UNITED STATES PATENT AND TRADEMARK OFFICE

APPLICATION NO.	FILING DATE	FIRST NAMED INVENTOR	ATTORNEY DOCKET NO.	CONFIRMATION NO.
10/086,316	03/01/2002	James R. Fore SR.	4287-008	8488

# Office Action Summary

## **DETAILED ACTION**

FIG. 1

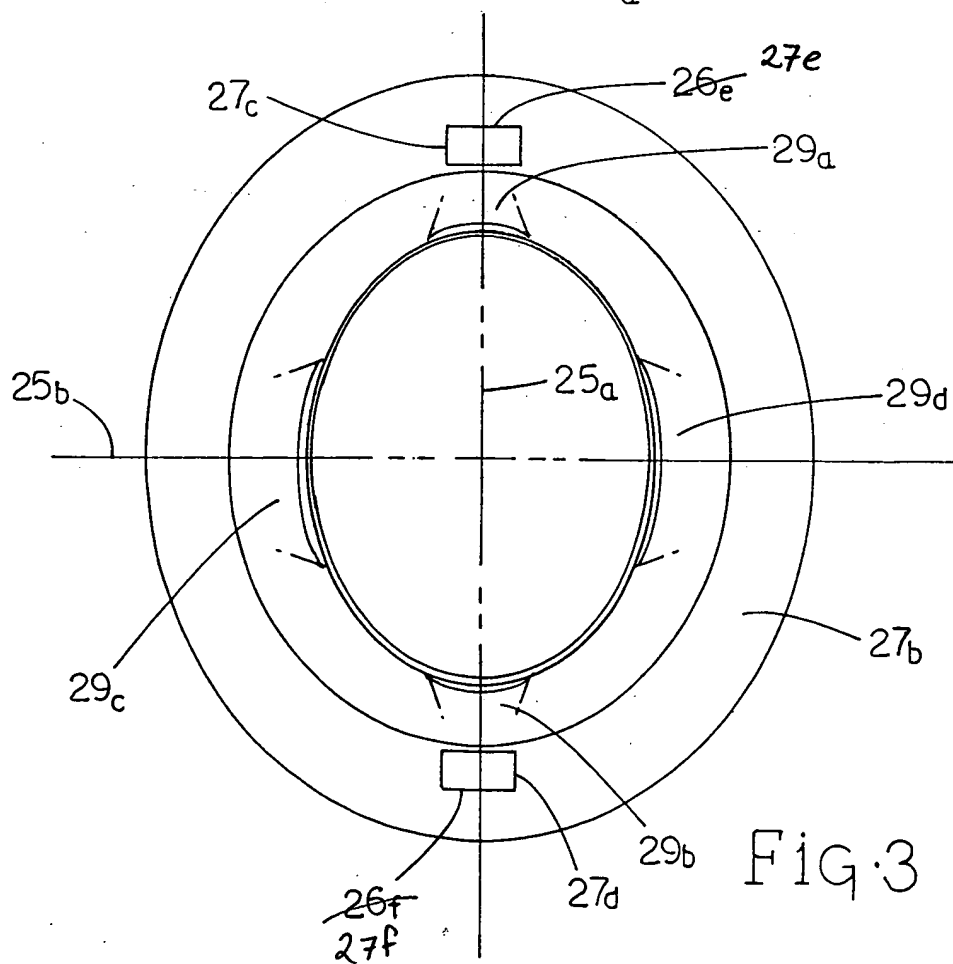
2. The drawings are objected to because: (see attached drawings):
- a. Fig. 1, rib "29d" should be "29b" since the rib is centered on the major axis;
  - b. Fig. 2, rib "29a" should be "29c" since the rib is centered on the minor axis;
  - c. Fig. 3, "26e" and "26f" should be "27e" and "27f", respectively, since they represent the two latch surfaces;
  - d. Fig. 4, the "27c" on the right end should be "29c" since it represents a rib, not an opening;
  - e. Fig. 5, latch surfaces "27f" and "27e" should be "27e" and "27f", respectively, to correspond to Fig. 4;
  - f. Fig. 5, in the cross-hatched area, "27a", "27b", "27c", and "27d" should be "29a", "29b", "29c", and "29d", respectively, since they represent the ribs; and
  - g. Fig. 7, the leader line of "11b" is missing and should point to the surface on the other side of "11a".
